**MEMO**

TO Stephen Davis  
 COPIED TO Hamish Wesney  
 FROM Alistair Osborne (Wellington Water Ltd)  
 DATE 27/04/2023  
 ACTION: **SUPPLEMENTAL INFORMATION**

**Responses to Hearing Panel Questions and submitters evidence**
**Background**

Figure 1: HCC Model extents

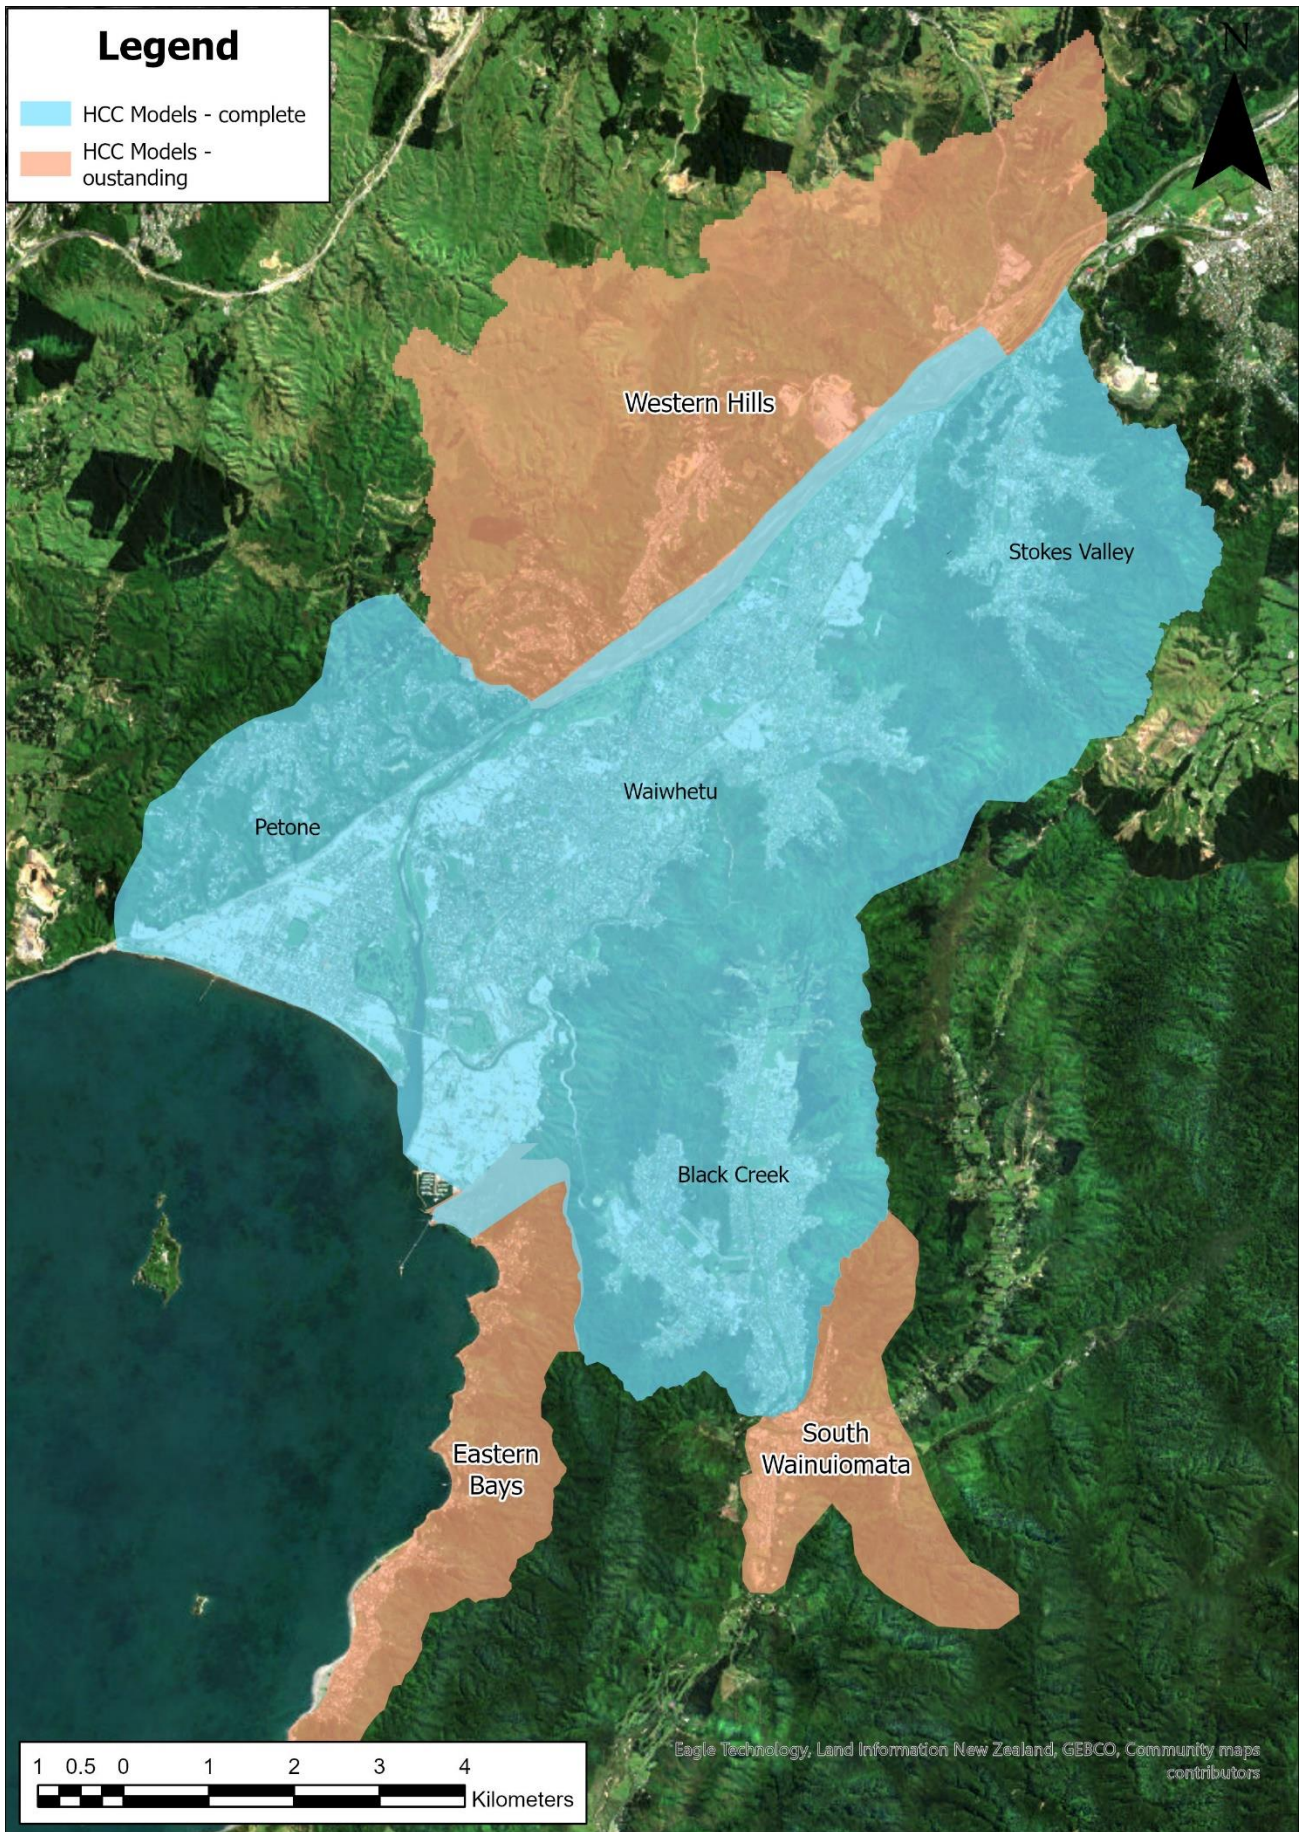
During the current PC56 Hearing I was asked to clarify the status of the flood models still outstanding for Hutt City Council (HCC). Below is information summarising the outstanding models, including a table showing the stages still to be completed and a map of all the HCC model extents.

Hydraulic models for the Eastern Bays and the western hills from Tirohanga north are still in development. No flood hazard layers have been developed for these catchments yet. The modelling for both these areas is expected to be completed by July 2023.

Modelling for South Wainuiomata was begun in March 2023 and will be combined with the modelling for Black Creek (Wainuiomata) to develop a full Wainuiomata model. It is expected that this will be finalised by June 2024. This will complete the stormwater modelling for Hutt City Council stormwater catchments.

Table 1 provides the target completion dates of the various progress stages for the three models noted above. Figure 1 shows the spatial extents of the areas that have been modelled along with catchments still to be modelled.
